Flight Procedures Cover Page	Task Action: Amendment	Task Type: SID	Estimated Chart Date: 06/17/2021	APWS Task ID: 227C50246D7C4656B5AFC49A4F20E6BF	APWS Project ID: 35B0DD9DB2404015952A91D305CC5B81
Procedure: SID BRADLEY FIVE		Enroute: YES	Specialist: Cappabianco, Anthony		Agreement Number:
Airport ID: KBDL			Airport City: WINDSOR LOCKS		State: CT
Facility ID:	Facility Type:	Flight Inspection Remark Type:			
<div>Procedure Comments: PROCESSED IAW AIRCRAFT OPERATIONS GROUP (AJF-10) MEMO, APRIL 29, 2020 SUBJECT: FLIGHT INSPECTION REVIEW NOT REQUIRED. CONTACT JOHN BORDY 405-954-0980.</div> <div>QUALITY 15 CHECKED</div> <div>QUALITY 8 CHECKED</div>

BRADLEY FOUR DEPARTUREWINDSOR LOCKS, CONNECTICUT
BRADLEY INTL (BDL)

Request ID: KBDL_191127

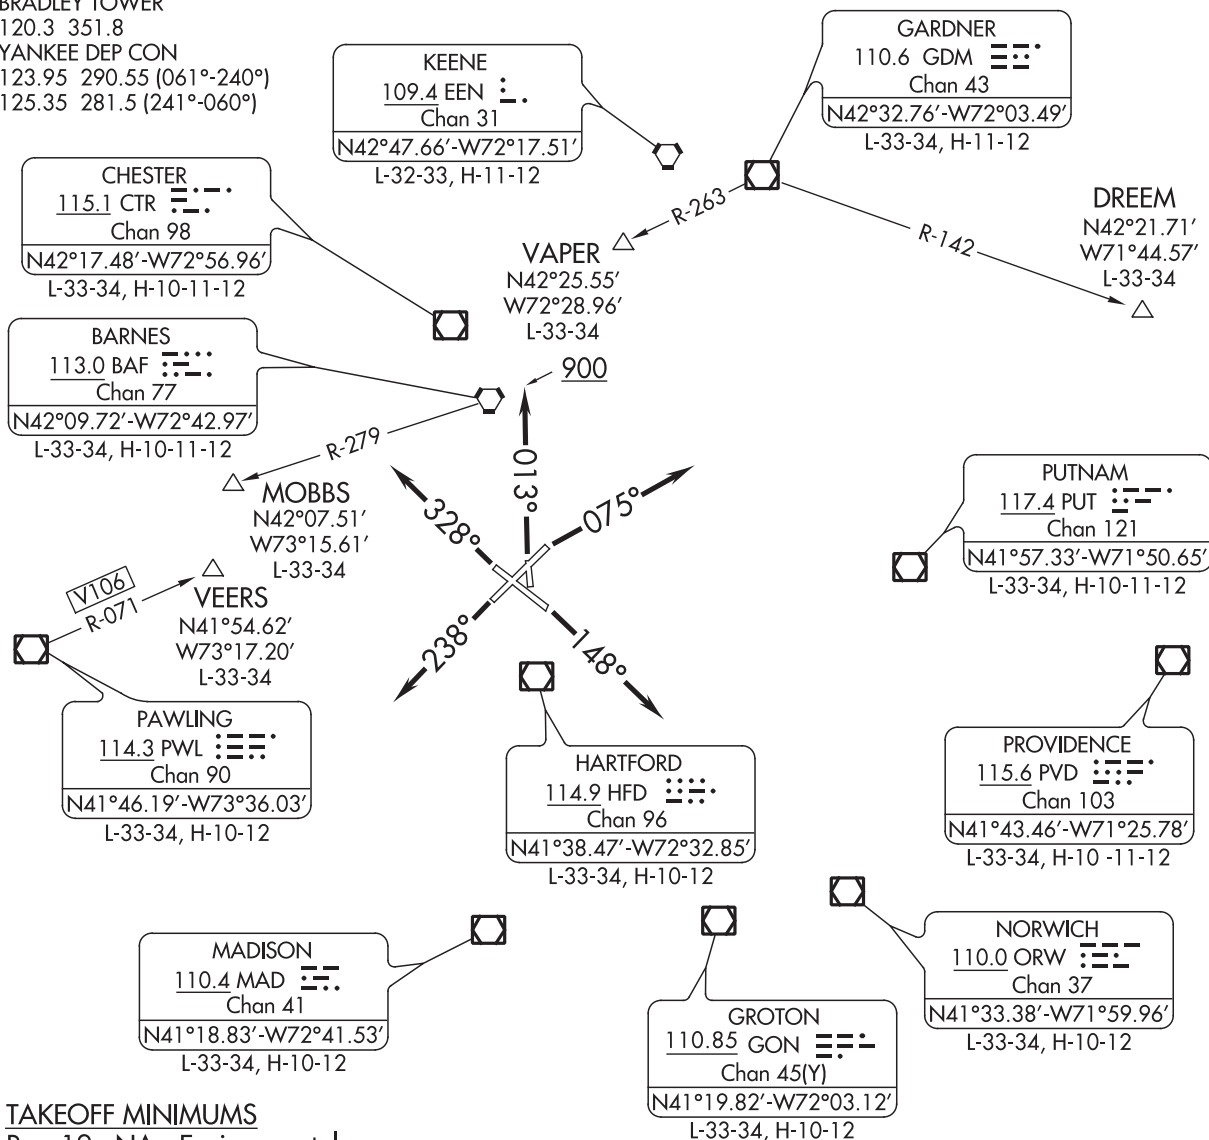
(1) Delete EEN, PUT, ORW, and PWL VORs and (2) delete PWL R-071 radial and V106 route.

EEN, PUT, ORW, and PWL VORs are being discontinued under the VOR MON program.
